Vacuum rf 6D Cooling Conclusion

R. B. Palmer
(BNL)

Wednesday 11/6/2013

Engineering Questions

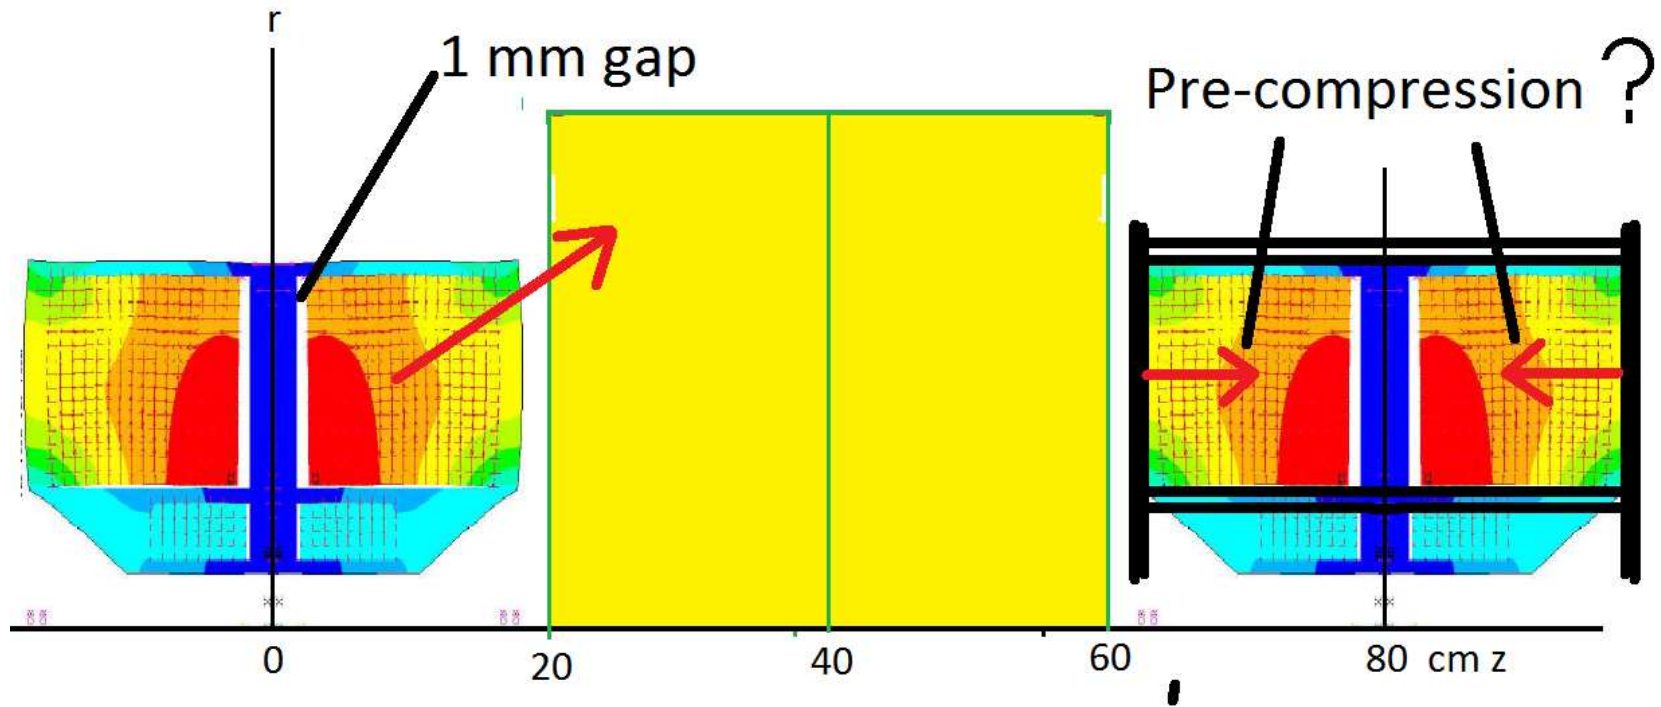
- rf Cavity design and waveguides. Diktys has already made modifications to the coil designs before the merge to allow straight radial waveguides. Similar modifications to stages after the merge do not appear difficult.

Both designs, for their initial stages, have specified rf windows with 25-30 cm radial apertures. For a 325 MHz cavity these are very large and will generate a lot of heating at the larger radii. The required Be thicknesses to cool these cases have not been determined. It has been noted that the beams are not centered on the coils in these designs, and that the cavities, to reduce this required aperture requirement, should be appropriately displaced. This required Be thickness will depend on the choice of cavity operation temperature. If operated at 77 degrees, instead of room temperature, the effect of such heating will be much reduced, due to the order of magnitude reduction in thermal expansion at the lower temperature..

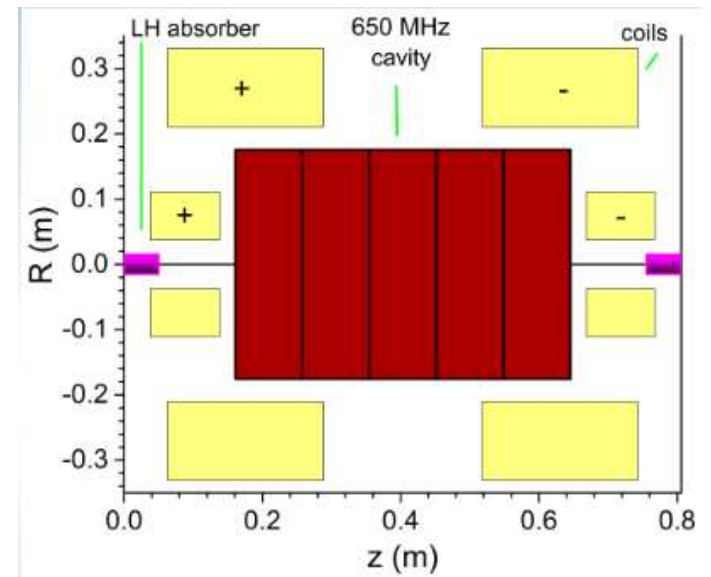
The current densities and calculated tension from coil radial forces appear to be within plausible limits for Nb₃Sn conductor. But, as shown by I. Novitski, the axial forces may be creating a problem. In the last stage of Valery's scheme, these forces, even after significant coil changes, are sufficient to move the conductors axially by as much as 1 mm. Novitski said, and I concur, that experience suggests that such motion would cause unacceptable training: a more normal limit for such motion would be 0.1 mm. Only actual coil construction and testing would confirm such a prediction, but this appears to present a problem.

The use of cable in conduit would drastically lower the average current density. Adding pre-compression could be considered.

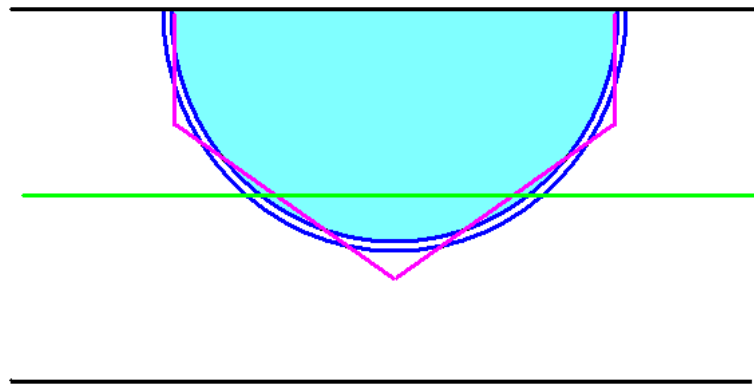
It is possible that Diktys' design will not be quite as bad because it does not need such a low beta function. But is still a worry.
